**LATE REPRESENTATIONS SCHEDULE**  
**PLANNING COMMITTEE – 8<sup>TH</sup> NOVEMBER 2017**

<b>PAGE NO. 178</b>	<b>APPLICATION NO: 17/01765/MJR</b>
<b>ADDRESS</b>	<b>225 ALBANY ROAD, ROATH, CARDIFF</b>
<b>FROM:</b>	Geraldine Wright
<b>SUMMARY:</b>	<p>Dear Mr Clemence</p> <p>We would like to lodge our response to the planning committee report in light of the amended plans for the above planning application. We maintain our position and continue to strongly object to the application. We are dismayed that the case officer yet again recommends that permission be granted.</p> <p>I would like to point out the following mismanagement of the process following the last Planning Committee Meeting on 11th Oct 2017 and I would ask that you read the following statement to the committee when the case comes up for discussion. I will be addressing the committee once again and I DO NOT want to use my precious 3 minutes raising the issues of transparency and information communication.</p> <p>1. As per the Planning Committee minutes of the meeting on 11<sup>th</sup> Oct 2017: the application was deferred.  Planning committee council members asked officers to draft reasons for refusal relation to KP5 a

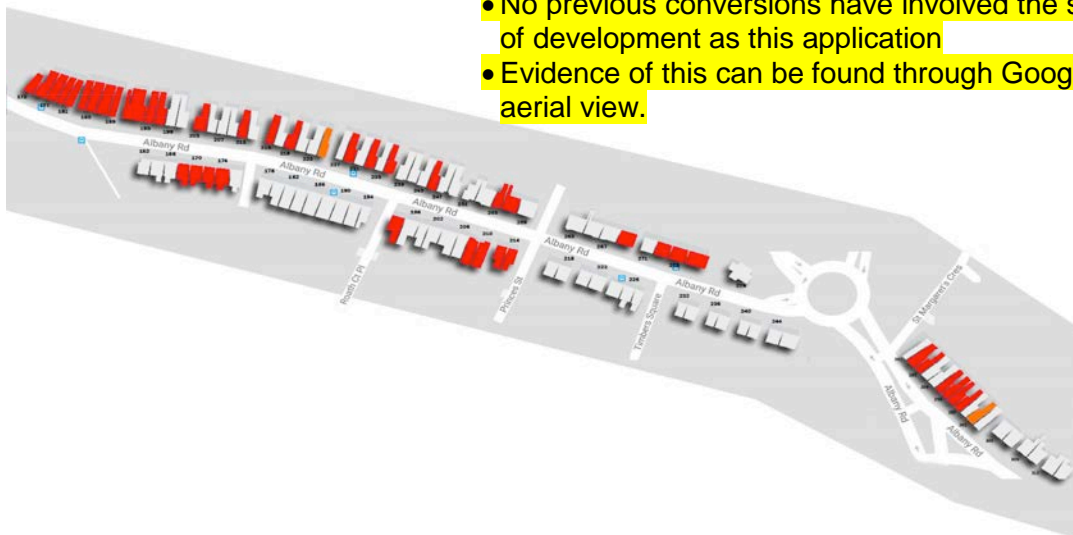
- The diagram below indicates the number of properties (shown in RED) already converted into flats. Results from our investigations demonstrate that 42% of houses in Albany Road are conversions

- None of these conversions encroach into the garden space, as does this application.
- Small dormer extensions are visible in only 4 properties on the Penylan ward side of the road
- No previous conversions have involved the scale of development as this application
- Evidence of this can be found through Google map aerial view.

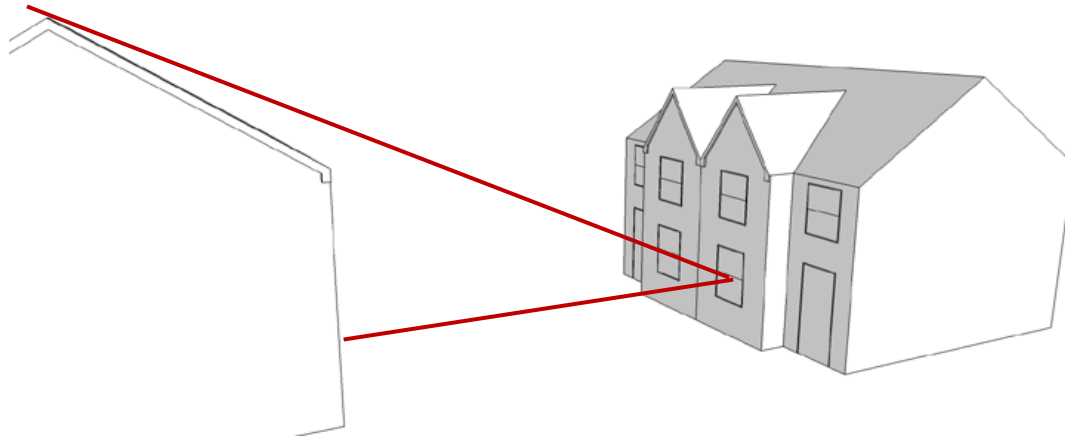
- There is an interpretation here of the Town and Country Planning (General Permitted Development) (Amendment) (Wales) Order 2013, which we are struggling to understand. The statement above suggests that the rear annexe dormer would constitute development permitted ..... **IF constructed prior to the conversions to flats.**

- Prevailing common sense would suggest that as the rear annexe dormer (or the dormer in the main roof) has **NOT** been constructed prior conversion to flats therefore it **CANNOT** be considered under the order of permitted development and has to be assessed as part of the overall development and conversion of the site.
- Despite the case officer's assumption that the rear dormer extension would have minimal impact on 227, we would strongly beg to differ. (see comments below)

It is not considered that the dormer extensions would be overbearing or generally un-neighbourly to justify concern for the local planning authority in this instance. The rear annexe dormer would have minimal additional overshadowing impact upon no. 227 to that already experienced by the existing two storey annexe and the main roof. Furthermore, the height of the rear annexe dormer would be lower than the ridge height of the existing main roof. In any case the rear annexe dormer would constitute development permitted under Class B of Part 1 in Schedule 2 of the Town and Country Planning (General Permitted Development) (Amendment) (Wales) Order 2013 if constructed prior to the conversion to flats.

Extension is an over-development of the plot

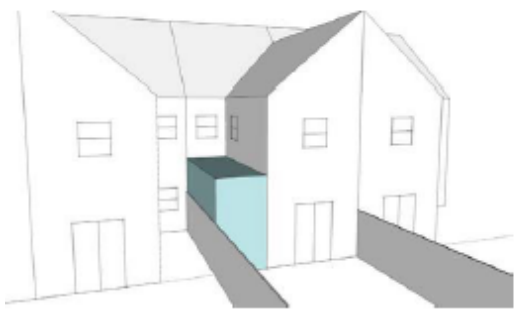
- *“For larger houses or those in areas where the establishment character includes good sized private gardens, any extensions or group of extensions/outbuildings beyond the permitted development limit, should ensure the retention of significant area of garden space. Proposals in this case will be considered in relation to character and context of the original house”*

- As pointed out already, much of the remaining external area is taken up with bin and cycle storage. The calculations above are incorrect 17.5m X 3.5m makes 61.25 m<sup>2</sup>. Our calculations suggest 47m<sup>2</sup> is what remains therefore the scale of the single storey extension is **NOT** acceptable.
- The rear extension does not maintain a reasonable extension to back garden ratio resulting in an overdevelopment of the original garden area
- Many residents will feel the visual impact as the extension would be visible across a wide ranging landscape.

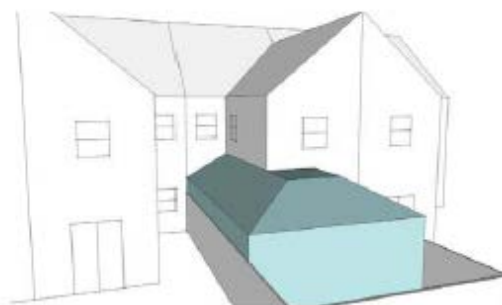
The height of the extension and position on the boundary is overbearing

Depth and height of extension is overbearing

- These diagrams help to illustrate the height of the wall of Flat 2 will overbear the neighbours in the garden of 223 Albany Road, resulting in the loss of the amenity of their garden. It will be 3 metres tall, very much higher than the existing stone garden wall. Their garden plants will be shadowed by the extra height running the entire length of the East side of the garden, and hit by water run-off from the extensive flat roof of Flat 2 at times of heavy rain.

The overall footprint would be very similar to the extension permitted by extant permission 15/01837/DCH and part of the extension encompasses the existing detached garage structure. Accordingly it is considered that it would not be out of character to the locality and will provide a subservient addition to the building. It should also be noted that a large proportion would constitute development permitted under Class A of Part 1 in Schedule 2 of the Town and Country Planning (General Permitted Development) (Amendment) (Wales) Order 2013 on the basis that: *the total area of ground covered by buildings within the curtilage of the dwelling house (other than the original dwelling house) would not exceed 50% of the total area of the curtilage (excluding the ground area of the original dwelling house); the height of the eaves of any part of the enlarged part which is within 2 metres of the boundary of the curtilage would not exceed 3 metres; and the enlarged part of the dwelling house would not extend beyond the rear wall of the original dwelling house by more than 4 metres.* The existing 3.8m single storey rear structure existed in 1948 therefore is considered original for the purposes of permitted development.

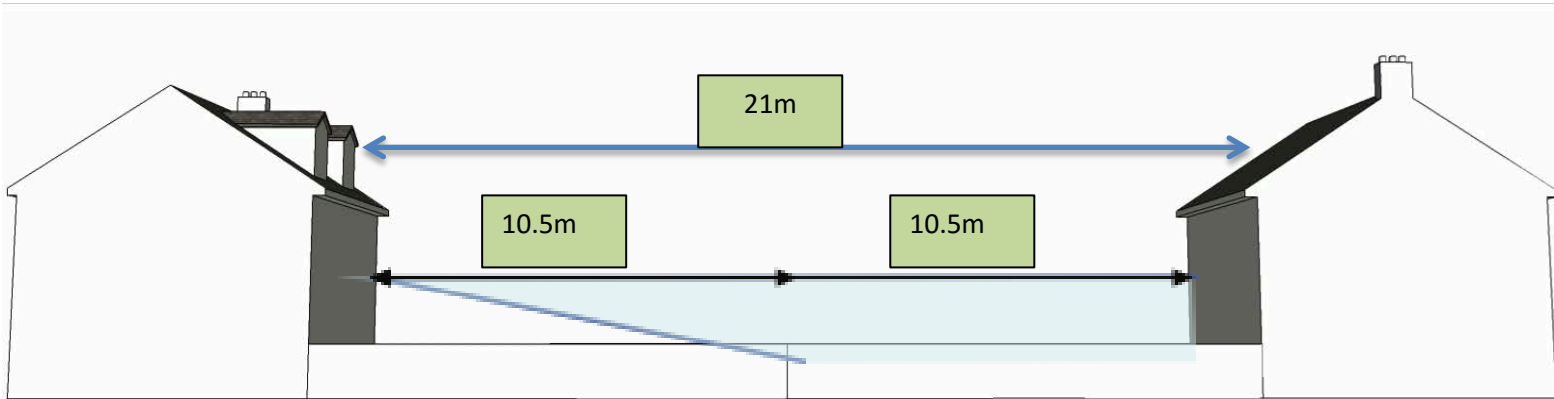
- With reference to points j, k and l. planning officers may not consider that there will be no loss of privacy or noise disturbance, but we consider there will be. It's all a matter of interpretation of policy and guidance documents and we refute the perspectives presented on these matters. SPG Residential Extensions and Alterations (June 2015) para 7.25 states: "In the case of extensions above single storey, a distance of 10.5m between

k) Loss of privacy/amenity from rear dormers. It is not considered that the proposal would result in any unreasonable loss of privacy or amenity to adjoining properties as detailed within the analysis above. The rear annexe dormer extension would constitute 'permitted development' not requiring planning permission if constructed prior to the conversion to flats. Local Development Plan policies and Supplementary Planning Guidance are not applicable to works which do not require planning permission. Condition 6 would ensure the south east facing windows of the rear annexe dormer shall be non-opening below a height of 1.7m above internal floor level. The references to the draft 'Cardiff Residential Extensions and Alterations' Supplementary Planning Guidance are noted, however this is draft guidance and has not been formally approved by the Council.
